**RE: Lisbon Valley Mining Co. LLC (Summo USA Corporation - Operator)
Request to Amend Mineral Exploration (Drilling) Program - Spring (April/May) 2000
Lisbon Valley Project**

Lisbon Valley Project
AMENDMENT TO
Spring (April/May) 2000
Exploration Project

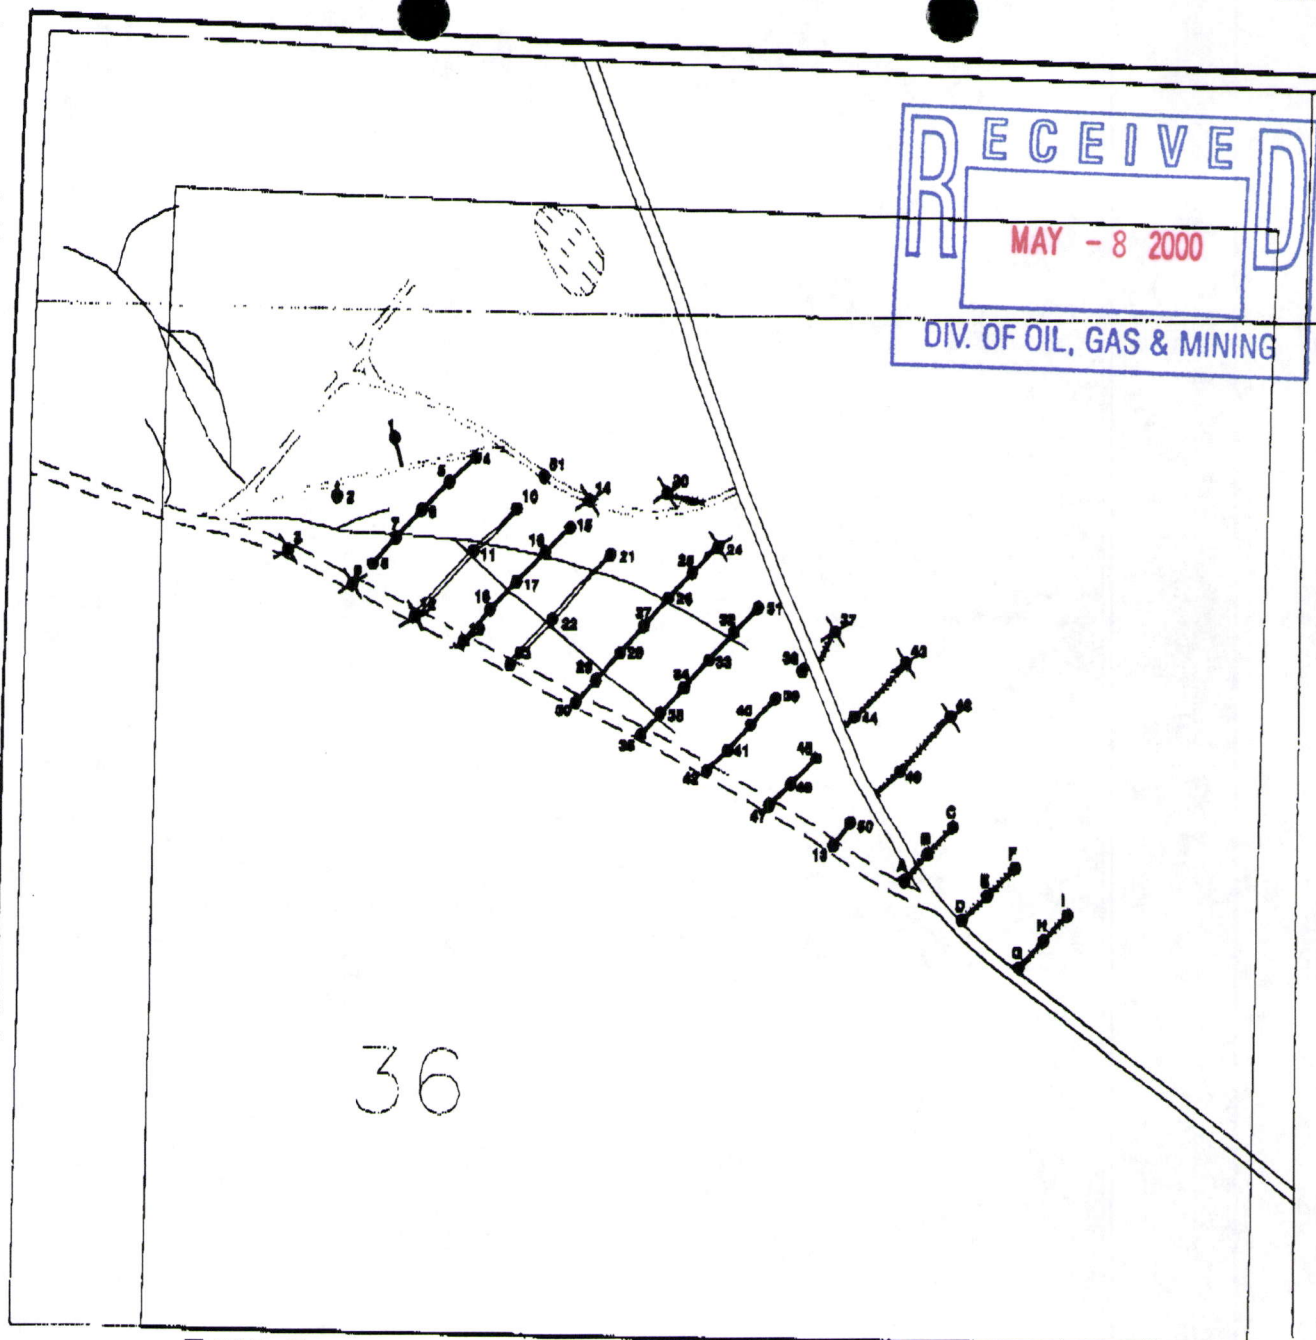
The change of locations involve the following previously approved sites and access (Drill sites - 3, 9, 12, 14, 20, 24, 37, 43, 48). Access construction and overland travel for these unconstructed/undrilled sites was estimated to total approximately 900 linear feet. The previously approved locations are shown on the attached map (Attachment 1). Summo projected that these nine (9) exploration holes would also potentially impact approximately 900 vertical feet of groundwater that would require plugging.

The amended drill hole locations, and their required access are also shown as Sites A, B, C, D, E, F, G, H, I, on Attachment 1. These amended activities will require 600 linear feet of access construction and/or overland travel, and approximately 150 vertical feet of groundwater that may require plugging.

This amendment request calls for no net increase in drill sites and will result in approximately 300 less linear feet of access needs. In addition, there will be a net decrease in groundwater hole plugging (approximately 750 feet).
